SALTON SEA GEOTHERMAL UNIT 6 POWER PLANT PROJECT

RESPONSES TO:
CALIFORNIA ENERGY COMMISSION
DATA REQUESTS, SET THREE (Nos. 107 - 138)

Application for Certification (02-AFC-02) for Salton Sea Geothermal Unit 6 Power Plant Project

File date: February 5, 2003

Figure LU-126A Example of SSU6 Signage

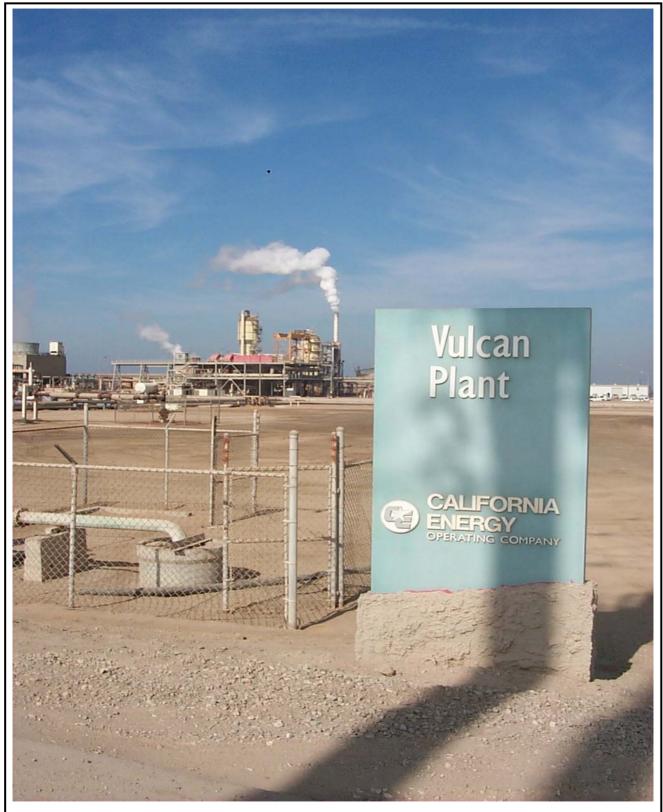
b. The materials that will be used to construct the signs;

c. The lighting technique that will be used for the signs;

The monument-style sign will be constructed of a textured cinderblock base (approximately 2 feet in height) with a metal sign anchored to the base. Figures LU-126A and LU-126B present an example of the proposed signs, subject to final design.

The monument-style sign will not be lighted as shown in Figure LU-126A. Overhead lights will light the control room signage.
